Substantive response of the Local Highway Authority to a planning consultation received under The Development Management Order.

Planning Application Number: 26/00325/FUL

Application Address: 36 London Road Markfield Leicestershire LE67 9UR

Description of Application: Dropped kerb and vehicle access for parking

The LHA understand from the Site Plan and Dropped Kerb Details (Drawing number 25/441 LRPO3) that the Applicant is proposing a new vehicular access within the junction radii between London Road and the parallel service road. This can be seen in the extract from the drawing overleaf.

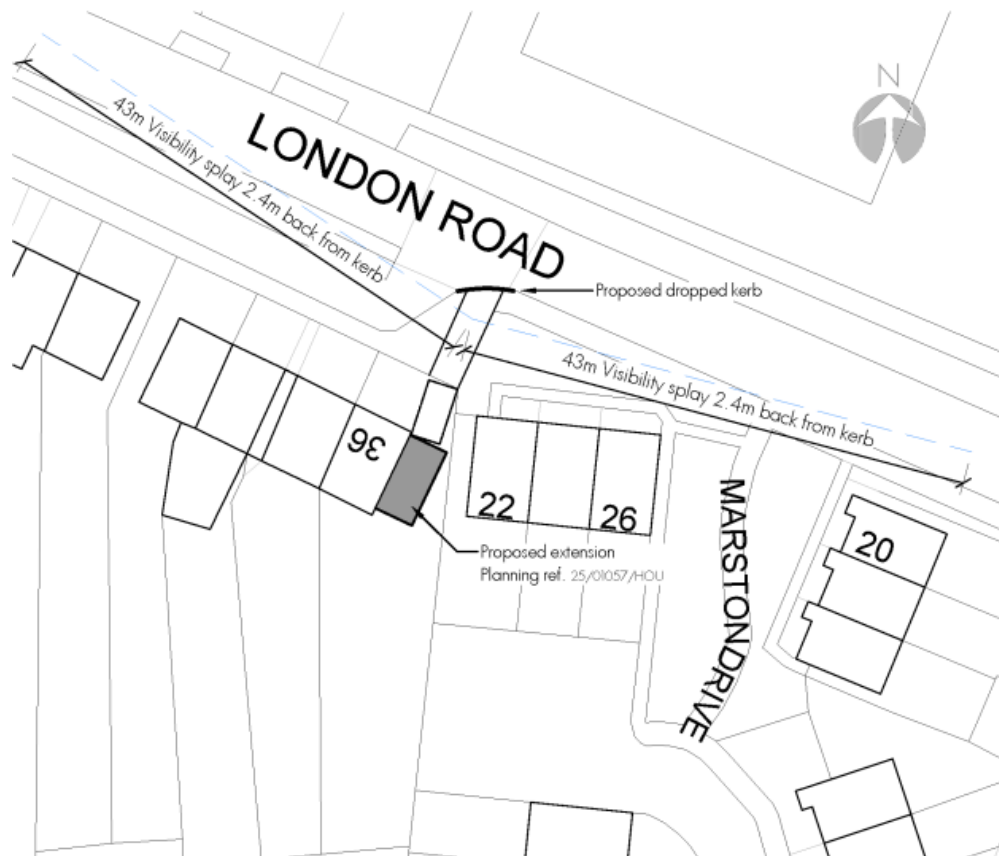
The LHA would raise the following highway safety concerns with the location of the proposed dropped kerb and vehicle parking:

- (a) It should be noted that the LHDG states that vehicle accesses should not be provided on to the corners (radii) of a junction. More information can be found [here](#) in the LHDG under 'Private Access Restrictions'. The LHA consider the introduction of a new access on a junction radius to be unacceptable on highway safety grounds, given that the required manoeuvre can be more complex as well as unexpected or misinterpreted by other motorists and road users, to the detriment of highway safety for all users contrary to paragraphs 115 and 116 of the NPPF (2024).

- (b) Drivers anticipating turning into the service road junction would be required to undertake a series of complex manoeuvres including deceleration and steering. This process also includes observation of both oncoming traffic and surrounding activity on London Road as well as the service road. The LHA believe that the location of the proposed vehicular access could cause confusion for other drivers. For example, a vehicle turning into the proposed development may need to slow down suddenly to prepare for the turning manoeuvre. Drivers following behind could misjudge where the vehicle intends to turn and assume that the vehicle is turning into the service road. Similarly, a vehicle entering the service road could be confronted suddenly by a vehicle leaving the proposed access, needing to stop or slow down suddenly. Such misunderstanding could delay the drivers' reaction times and increase the likelihood of 'rear-shunt' collisions.

- (c) As the Applicant is proposing to introduce the vehicular access on the junction radii, the LHA believe that the access would not be perpendicular to the highway. As such, vehicles would not egress or access the site at 90° to the highway. This could promote complex manoeuvres in a highway with high traffic flows, to the detriment of highway safety for all users contrary to paragraphs 115 and 116 of the NPPF (2024).

- (d) In addition, the LHA believe that the introduction of a new vehicular access in the proposed location could also cause confusion for pedestrians travelling on the footway. If a vehicle were to access the development site via the proposed access, pedestrians travelling on the footway may believe that the vehicle is intending to turn onto the service road, not the proposed access. As a result, pedestrians could continue travelling on the footpath, which could increase the risk of collisions, detriment to their highway safety contrary to paragraphs 115 and 116 of the NPPF (2024).

The LHA welcome the scaled drawing that the Applicant has submitted demonstrating visibility splays (Site Plan and Dropped Kerb Details Drawing number 25/441 LRPO3), but it is noted that the splays have been drawn incorrectly at a 5 metre setback rather than at a 2.4 metre setback. As such, the LHA have therefore conducted their own assessment calculating the maximum achievable visibility.

The LHA have calculated from the Proposed Site Plan within the Site Plan and Dropped Kerb Details that the proposed off-street parking space measures 4.3 metres x 2.5 metres, not 4.84 metres x 2.5 metres as annotated on the drawing.
